Q1. Why is Xilinx standardizing to 10-layer for Virtex-5 packages with more than 1000 pins?

Q2. What are the differences between the 8-layer and 10-layer packages?

XTP027_01_061009

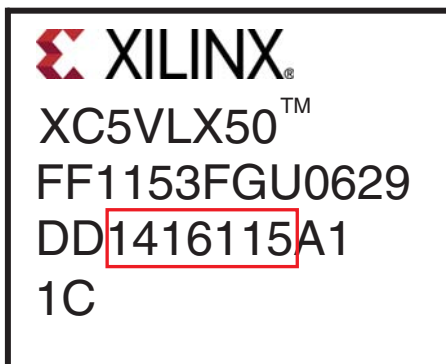
Q11. How do I know whether I have the new 10-layer package?

A. To trace the packages in your possession, please contact Xilinx Customer Service at csgroup@xilinx.com, and provide the 7- digit Lot ID (see example top mark below). Xilinx Customer Service can identify if the order was shipped with 8-layer or 10-layer packages.
